System Impact Assessment Report For Niagara-Nanticoke Area Cluster

273 MW New Generation at Thorold by Northland Power
CAA ID Number 2000-003

**990 MW Interconnection Across Lake Erie by TransÉnergie US and
HydroOne Inc.**
CAA ID Number 2000-017

Final Report

Diagram A. Nanticoke 230 kV - Power Flows Maximum Import & Generation

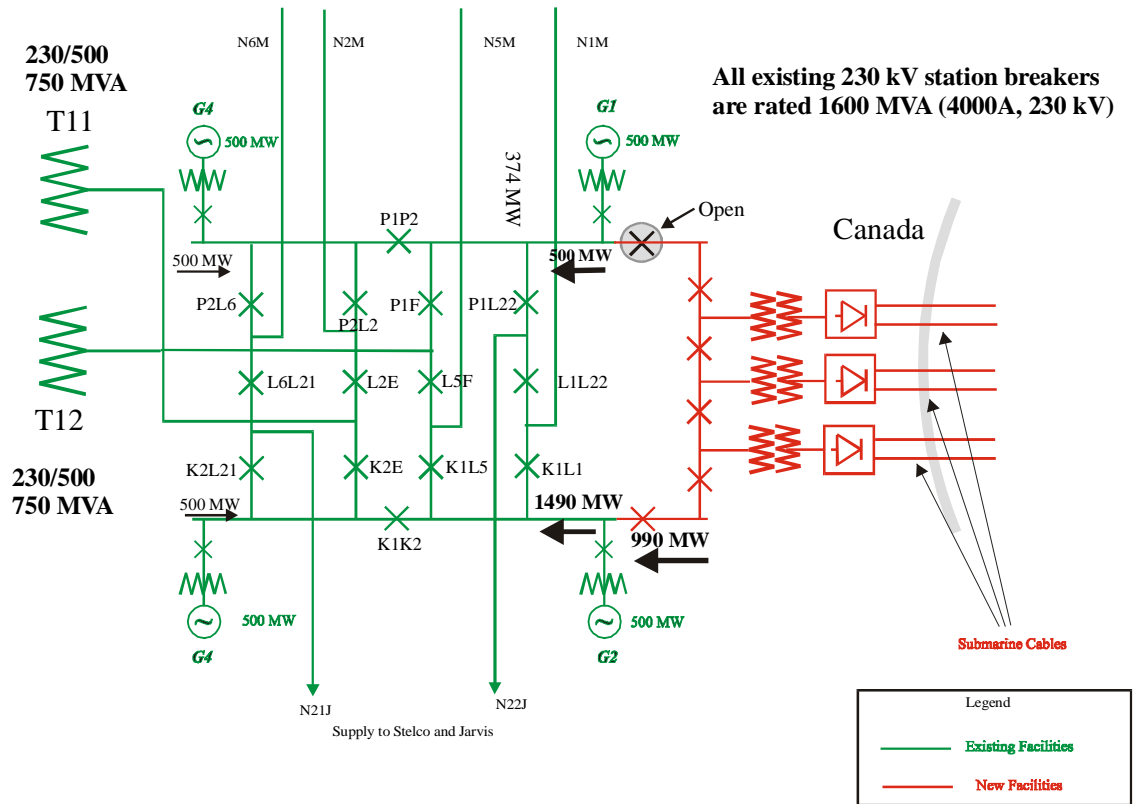
Diagram A shows the maximum power that would be flowing through the station for one critical breaker out of service, with all generation and the HVdc bipoles in service. The calculations show that the continuous rating of the station breakers is high enough (4000 A) to sustain maximum power flows without any risk for damage.

At this time, the rating of the station bus work is not available, hence an assessment of its thermal adequacy could not be made.

The applicant is required to obtain and forward to the IMO the thermal rating of the Nanticoke 230 kV station bus work. The IMO will assess whether or not for certain system scenarios it is adequate to support the full output of the proposed HVdc Interconnection. If certain sections of the bus work or other station equipment are found to be overloaded for all station elements in service or one element out of service then, the applicants will be required to initiate and undertake work to replace these station equipment and coordinate this work with Hydro One Networks Inc.

Figure 2. NORTHLAND POWER THOROLD GS
Single Line Diagram

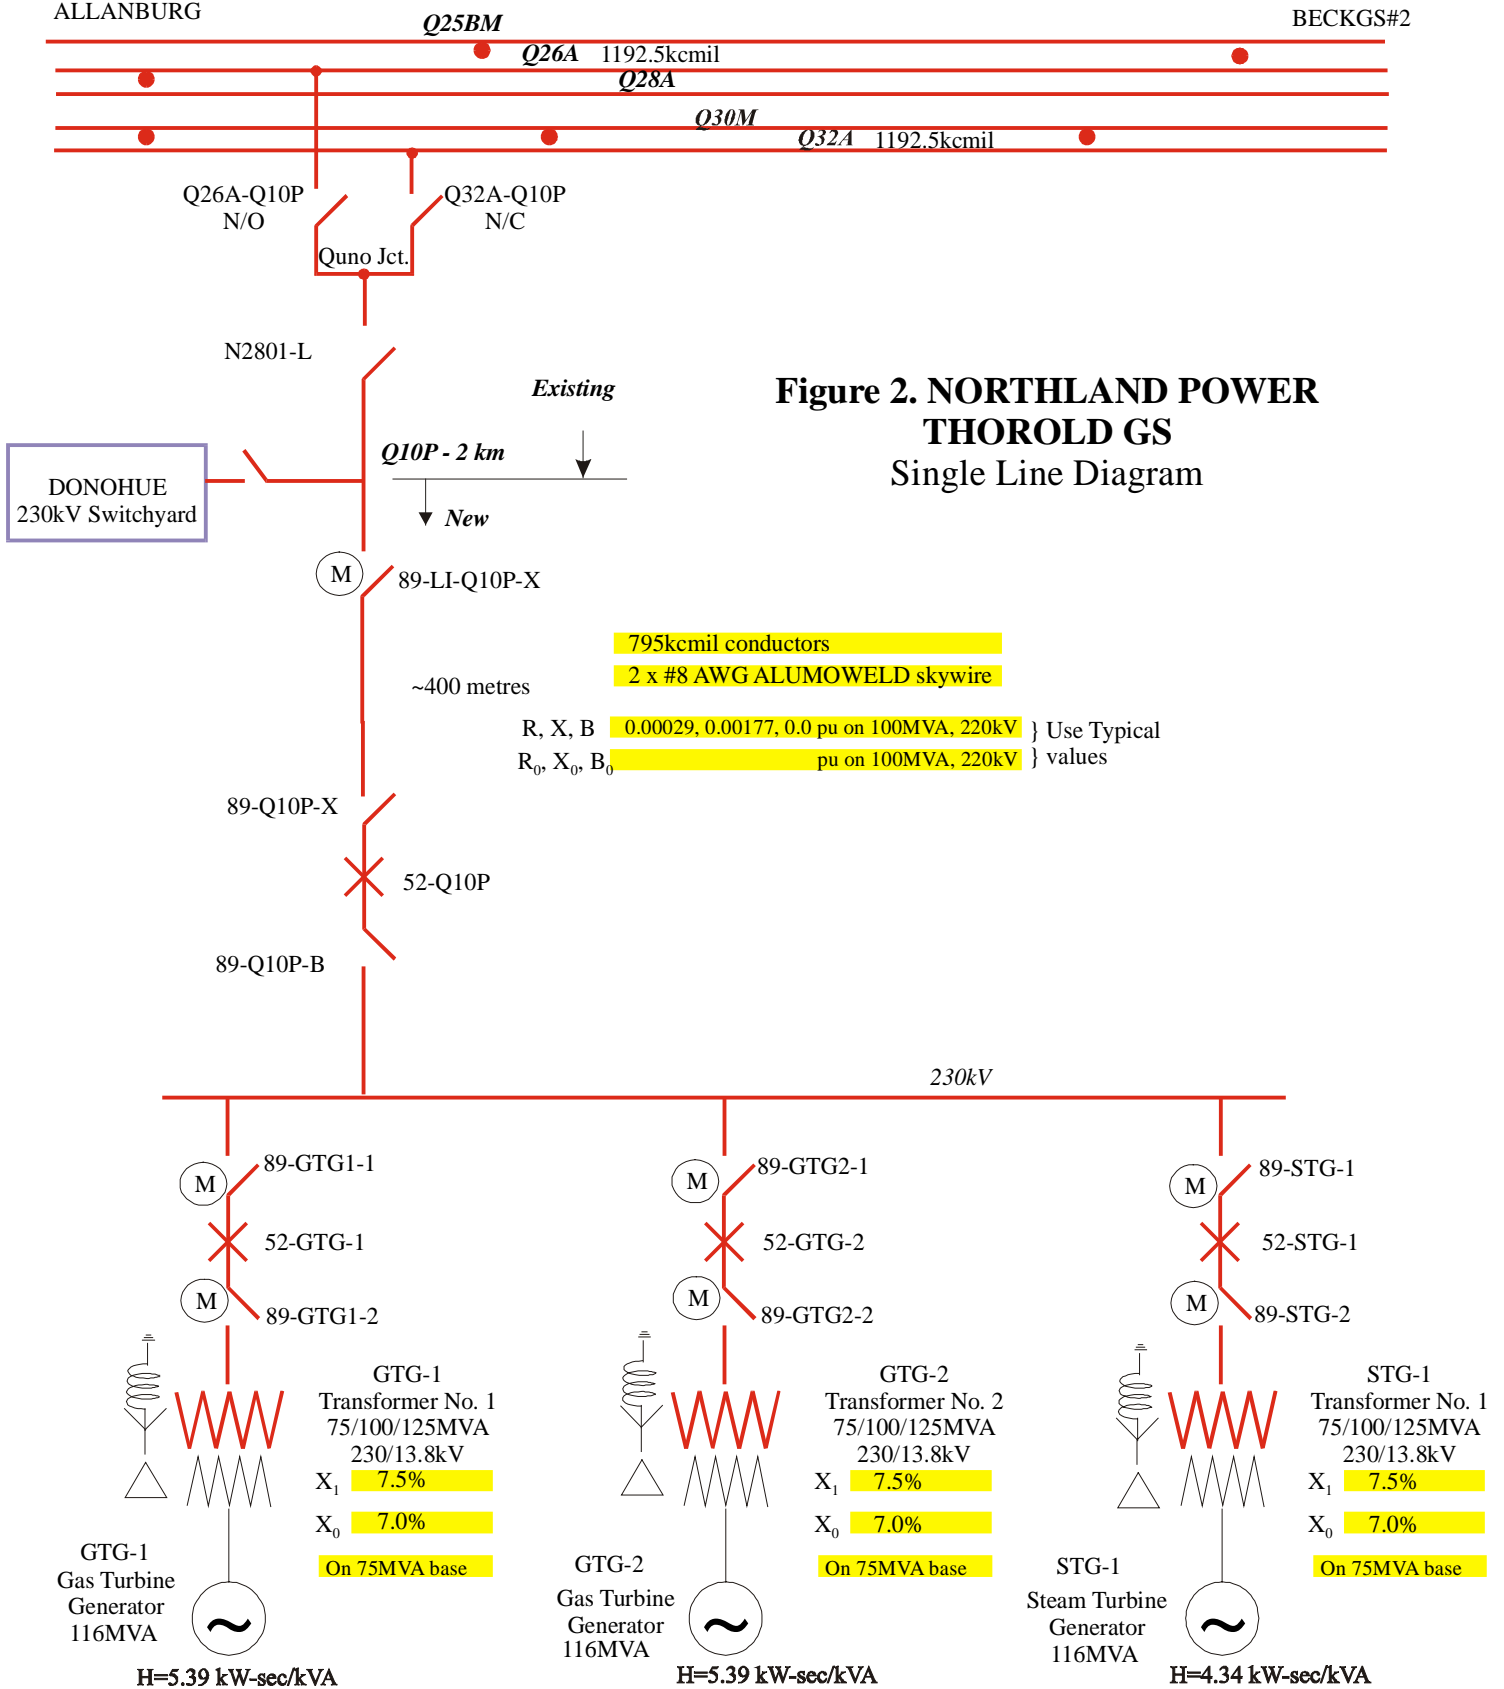
Thorold GS project is to be connected to the *IMO-controlled grid* via a 400 m line tap. The line will be equipped with a HV breaker with associated manually-operated disconnect switches at the generator HV bus end, and one motorized line disconnect at the other end. This arrangement in Figure 2 meets the requirements of the Transmission System Code.

It is required that the power injected into the 230 kV circuit Q10P does not exceed at any time the continuous rating of this circuit.

1. Thorold GS project is to be connected to the *IMO-controlled grid* via a 400 m line tap equipped with a HV breaker with associated manually-operated disconnect switches at the generator HV bus end, and one motorized line disconnect at the other end. This arrangement in Figure 2 meets the requirements of the Transmission System Code. It should be noted that the TSC requires that only the disconnect switch 89-LI-Q10P-X be motorized.

Figure 3. Connection to Nanticoke 230 kV

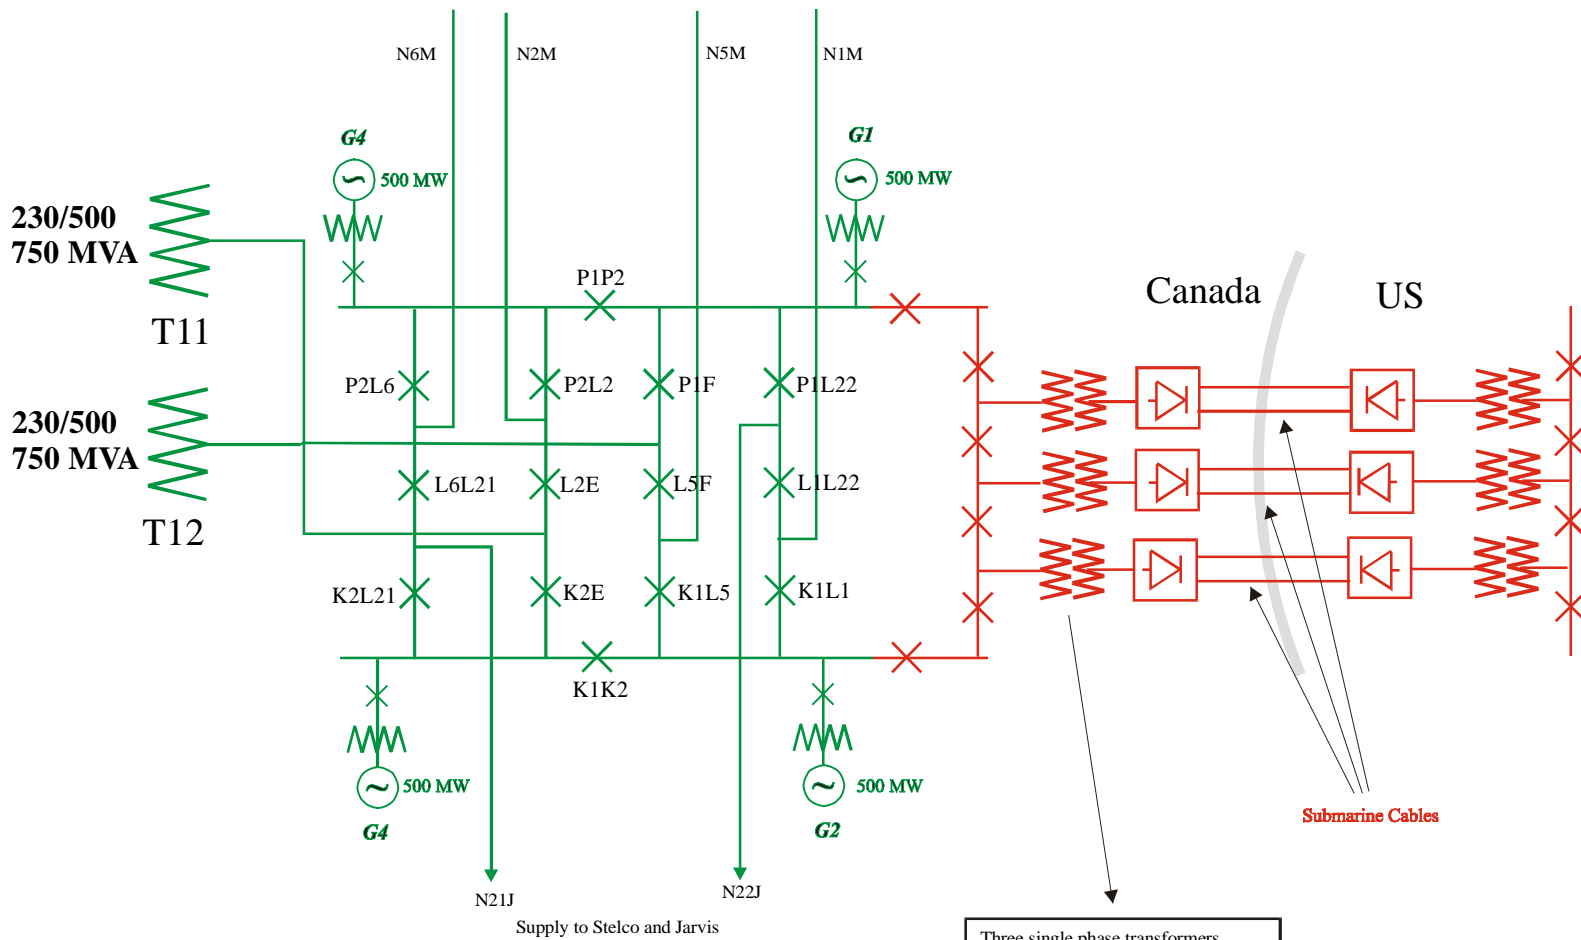
The connection of the three HVdc bipoles to the Nanticoke 230 kV switchyard is to be made via six 230 kV breakers and the associated bus and station diameter work as shown in Figure 3. It is required that the installation of the first 330 MW HVdc bipole will provide four 230 kV breakers at the 230 kV Nanticoke TGS. For the subsequent stages, a new breaker has to be added with the installation of each bipole.

Studies show that the Lake Erie HVdc Interconnection contributes up the 6.3 kA to the short circuit currents at the Nanticoke 230 kV bus, thus bringing the fault currents above the interrupting capability of the existing breakers.

It is required that TransÉnergie US Ltd. and Hydro One Inc., implement one of the following two options for reducing the line-to-ground fault currents at Nanticoke TGS:

The studies show that in order to reduce sufficiently the line-to-ground fault current at Naticoke TGS, it is required that at least 5.0 ohms neutral reactors be installed on the Naticoke step-up transformer T2 and on all three of the HVdc converter transformers.

1. The connection of the three HVdc bipoles to the Naticoke 230 kV switchyard is to be made via six HV breakers and the associated bus and station diameter work as shown in Figure 3. It is required that the installation of the first 330 MW HVdc bipole will provide four 230 kV breakers at the 230 kV Naticoke TGS. For the subsequent stages, a new breaker has to be added with the installation of each bipole.

Figure 5. Stages of the Lake Erie Interconnection Project

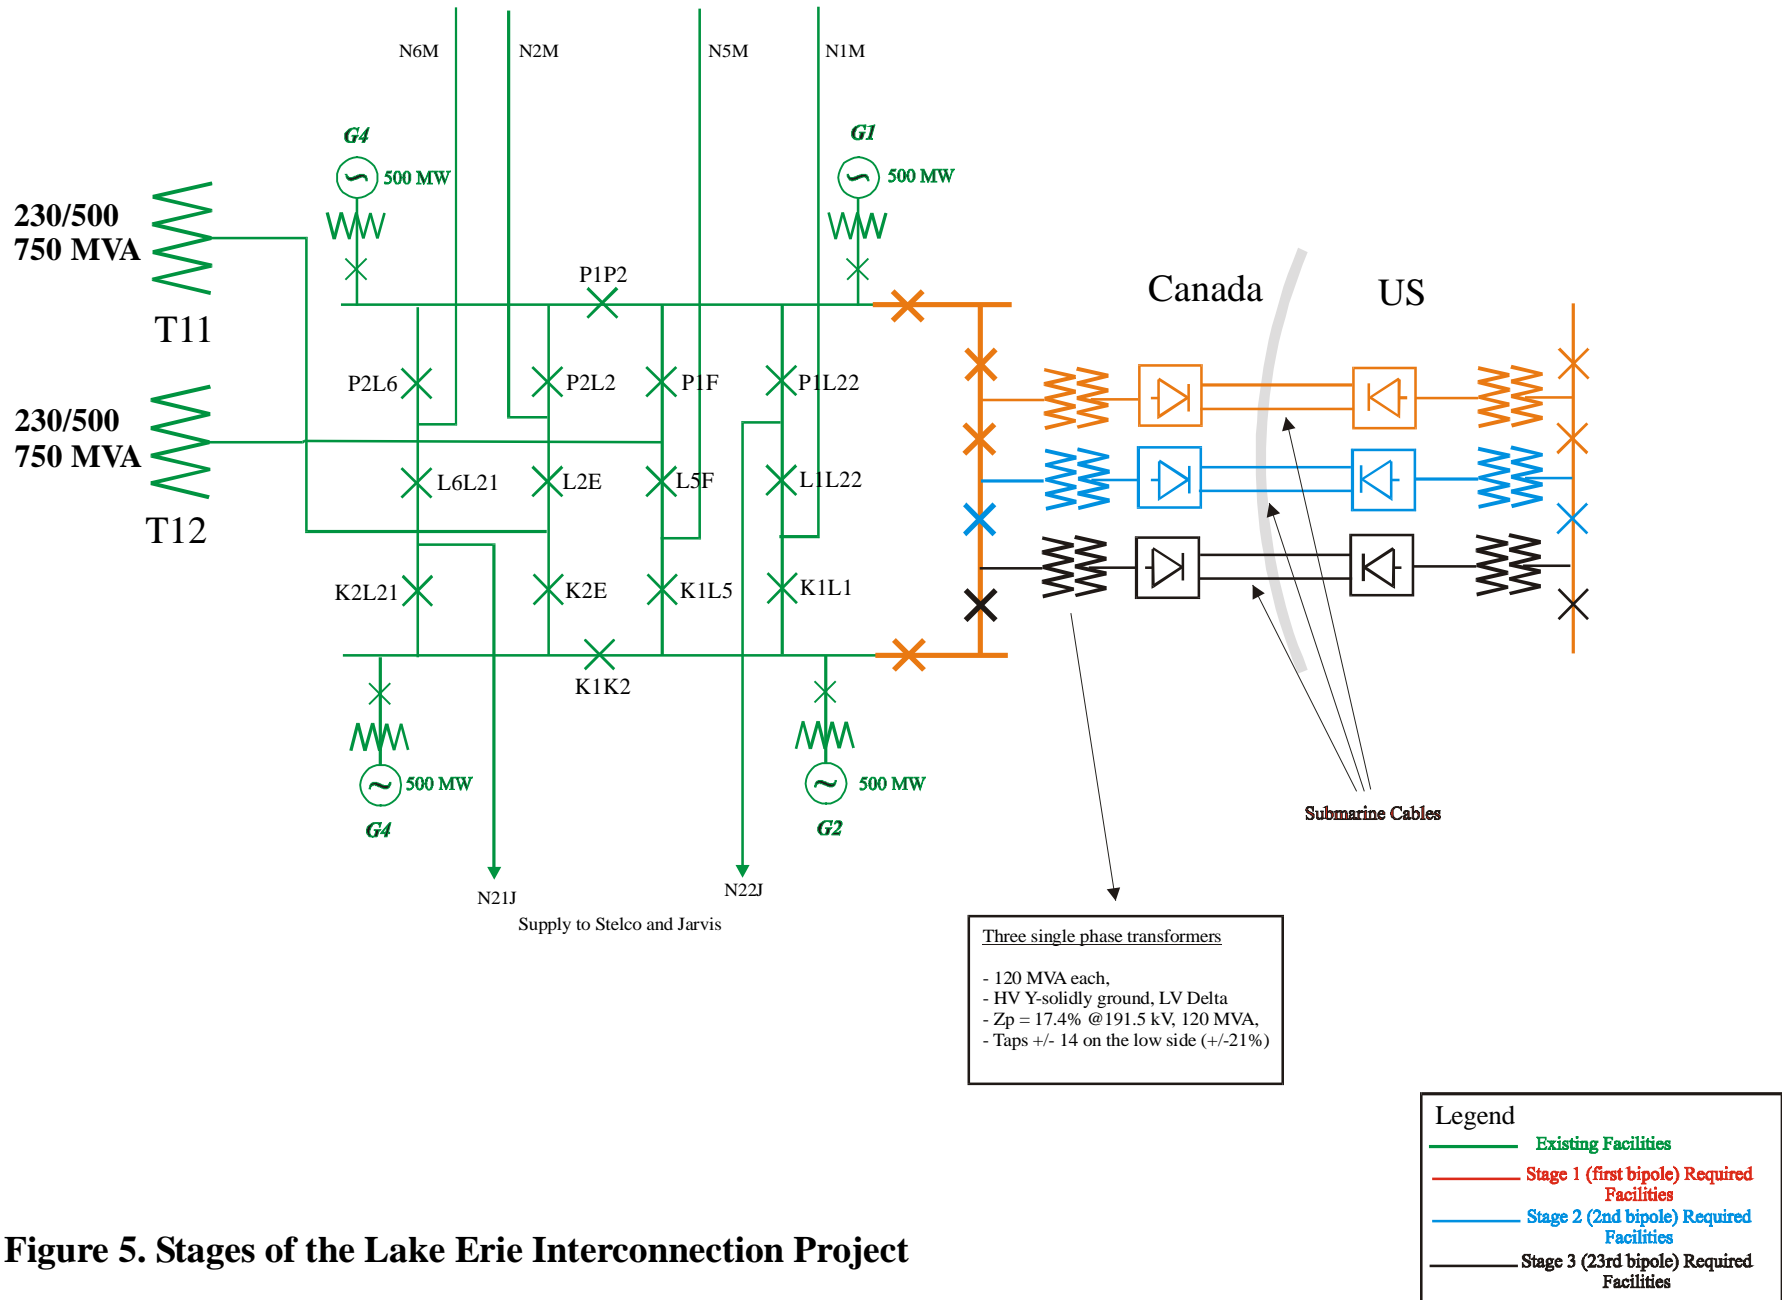
For the subsequent stages, when the second and third bipole will be installed a new breaker must be added with every bipole.

The facilities required to be installed with every stage are shown in Figure 5.

Figure 6. Both Projects Versus Existing System-Transient Comparison

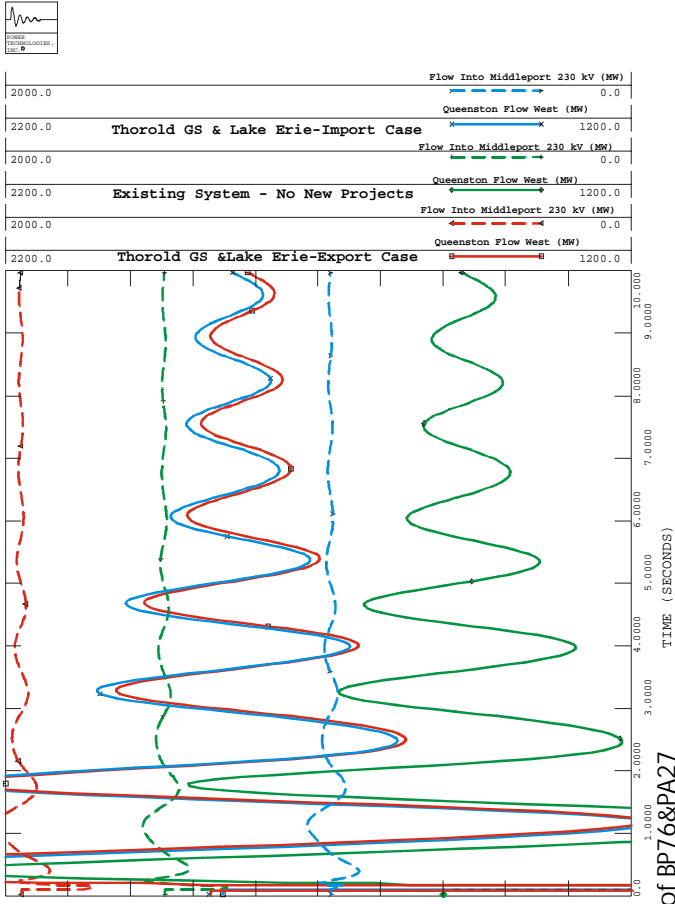
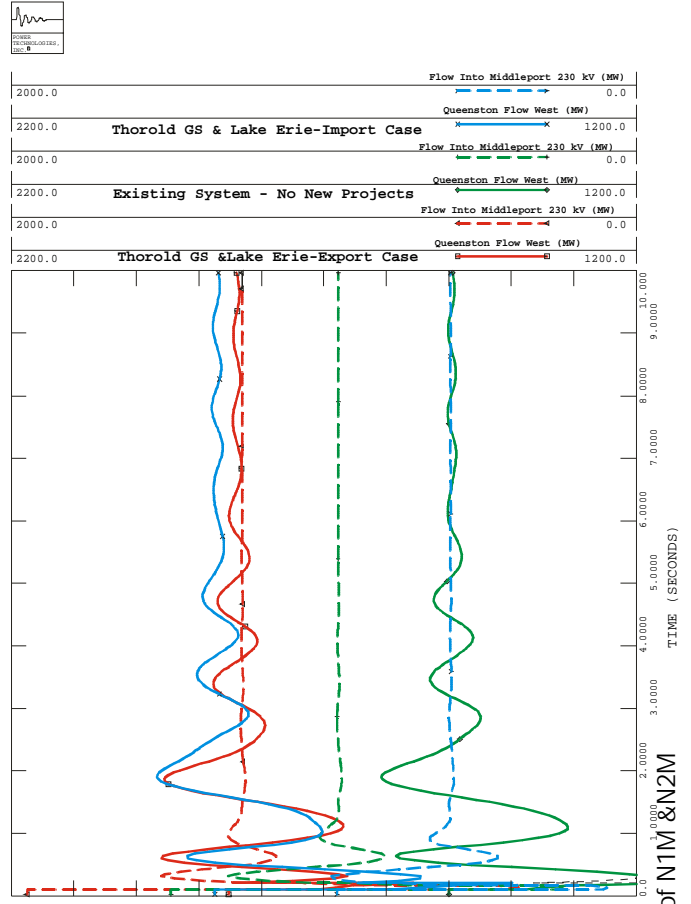
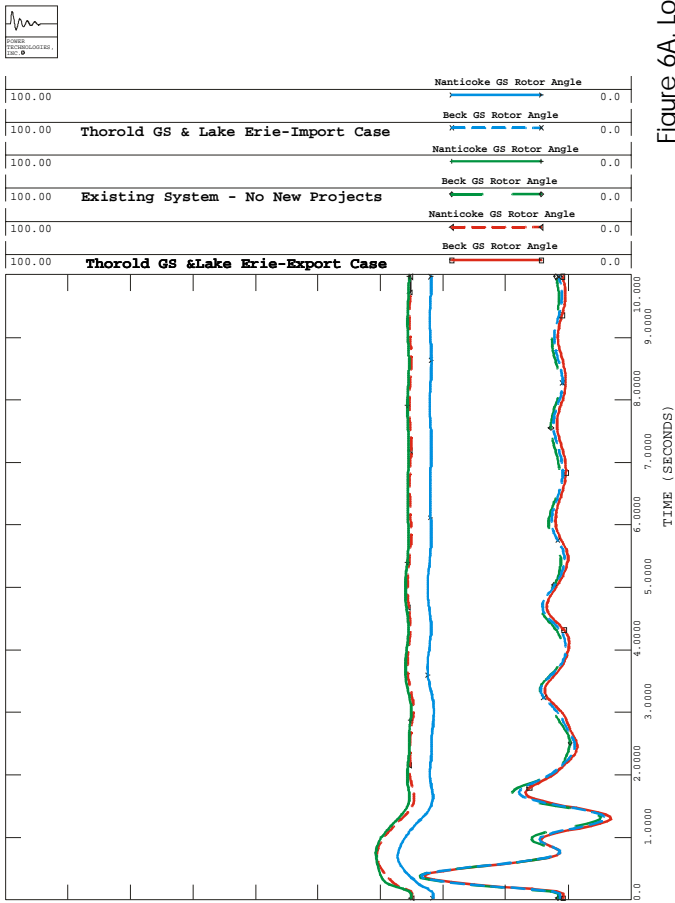
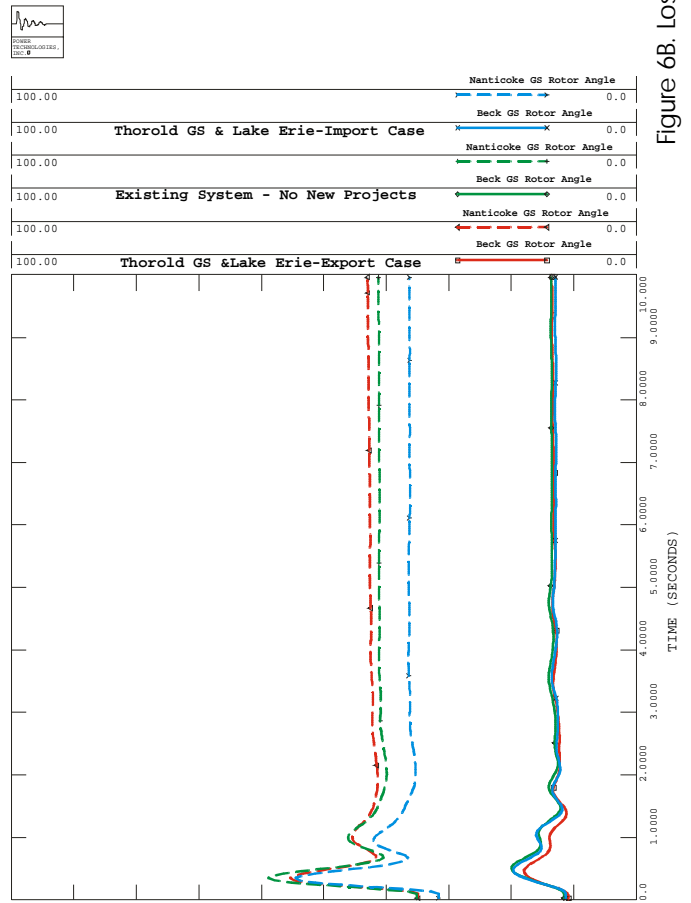
In addition to the detailed contingency analysis presented in Table 6, a comparison was performed between the transient response of the existing system and that of a system including both projects. Two of the most critical faults were selected for this comparison, namely the loss of one of the double circuit 230 kV interconnections to New York at Niagara (BP76 & PA27) and the loss of one double circuit 230 kV line between Nanticoke 230 kV station and Middleport 230 kV TS. The comparative transient responses of selected machine rotor angles and interface power flows are shown in Figure 6.

It can be concluded from Figure 6 that the addition of the two proposed projects does not aggravate the amplitude or damping of the oscillatory system response to the contingencies that were studied.
